Land and Environment Court New South Wales

Medium Neutral Citation:	Steve Macri v Northern Beaches Council [2024] NSWLEC 1195
Hearing dates:	Conciliation Conference on 1 March 2024
Date of orders:	18 April 2024
Decision date:	18 April 2024
Jurisdiction:	Class 1
Before:	Porter C
Decision:	The Court orders: (1) The appeal is granted. (2) Development consent DA2020/1351 is modified in the terms in Annexure "A". (3) Development consent DA2020/1351 as modified by the Court is Annexure "B".
Catchwords:	MODIFICATION APPLICATION – shop top housing – conciliation conference – agreement between the parties – orders
Legislation Cited:	<i>Environmental Planning and Assessment Act 1979</i> , ss 4.15, 4.55 <i>Land and Environment Court Act 1979</i> , s 34 <i>Environmental Planning and Assessment Regulation 2021</i> , ss 102, 113 Pittwater Local Environmental Plan 2014 State Environmental Planning Policy (Housing) 2021, s 147 State Environmental Planning Policy (Transport and Infrastructure) 2021

DETERMINATION OF APPLICATION FOR MODIFICATION OF DEVELOPMENT CONSENT

Modification Application No:	Mod2023/0474
Development Consent modified:	DA2020/1351
Description of development to be carried out un

S 88A Easement PLAN

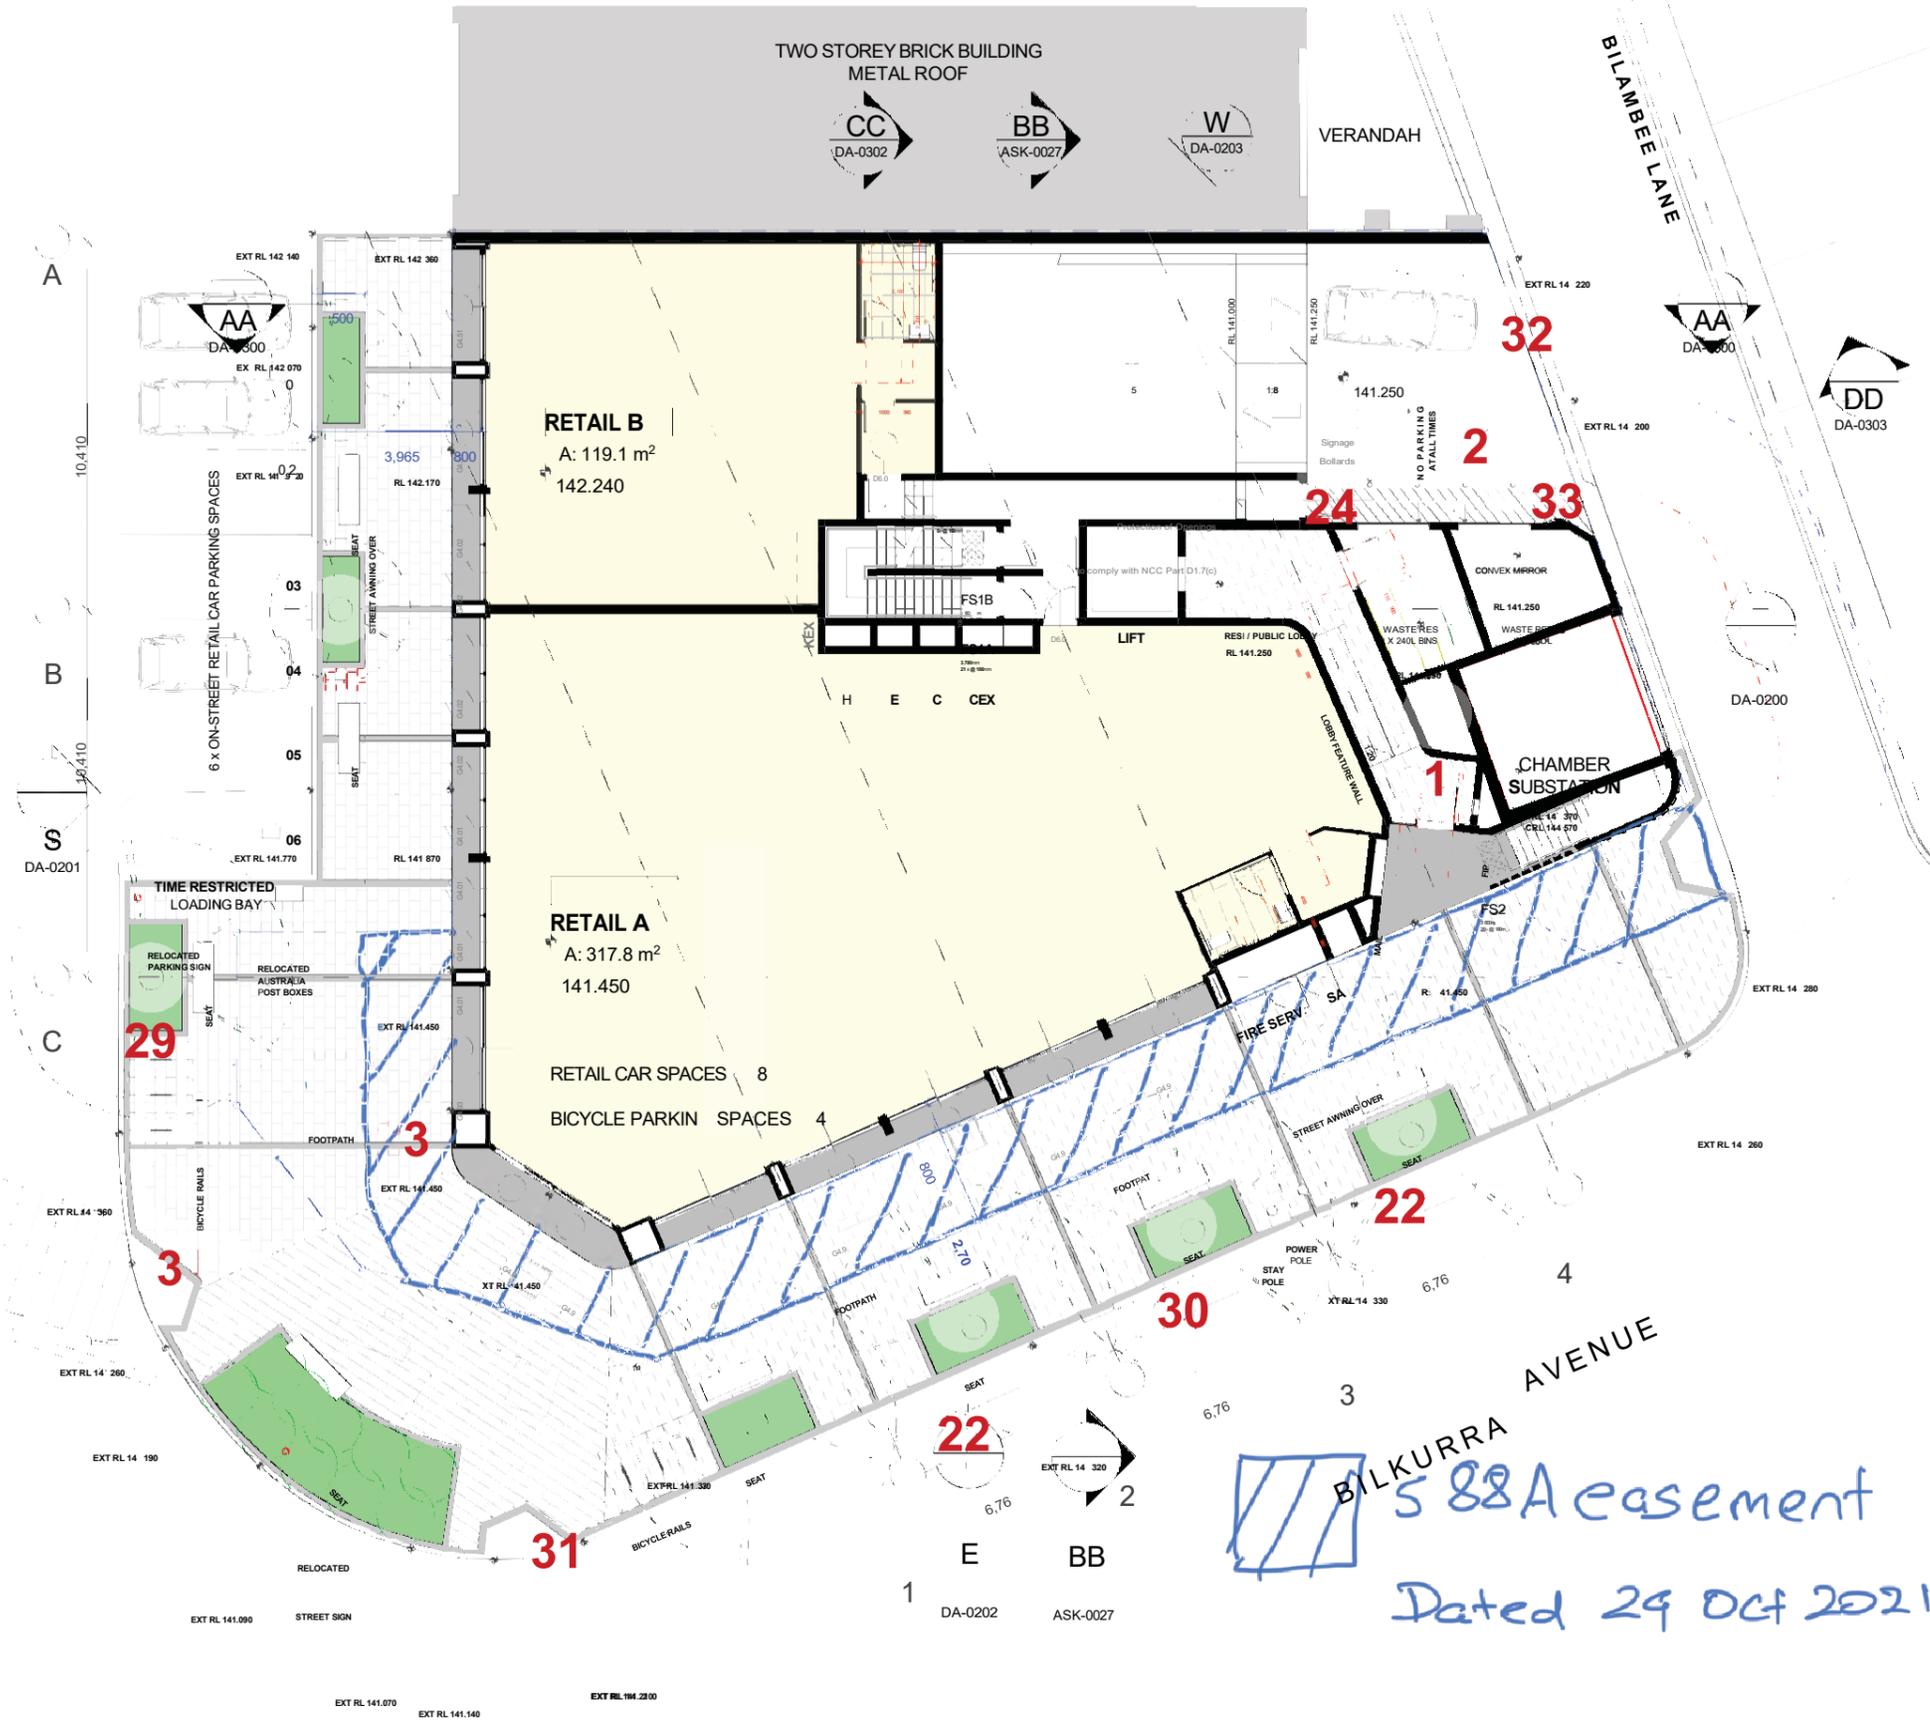
A right of footway in favour of the Council is to be registered on the title of the land under section 88A of the Conveyancing Act 1919 for that part of the land shown as "s 88A easement" on the attached s 88A Easement PLAN dated 29 Oct 2021 (the only purpose of this plan is to show the area of the easement and no development is approved by this plan). The owner of the land must maintain this area of the land to the Council's satisfaction and take out, maintain and fund appropriate insurances for this area of the land as required by the Council. This easement is to continue in the event of any strata or community title subdivision of the land and this area of the land is to be in the ownership of the owners corporation.
